DATE: 03.14.2016
TO: ProTrak
FROM: Bill McDow
 Transportation Planning

■ **OGDEN MARKETPLACE [TRC Plan Review]**

↻ Initial Review Note ↻

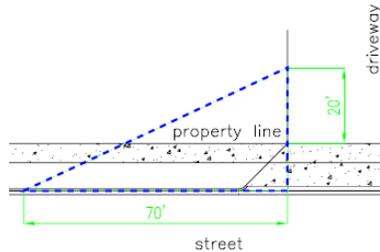
1. The proposed Right Turn lane at Market St and Middle Sound Loop Rd, (Site access #3), appears to be located outside the NCDOT ROW and on private property. If this portion of the

site property is proposed to be new ROW dedicated for public use, please indicate the dedication and any easements on the site plans.
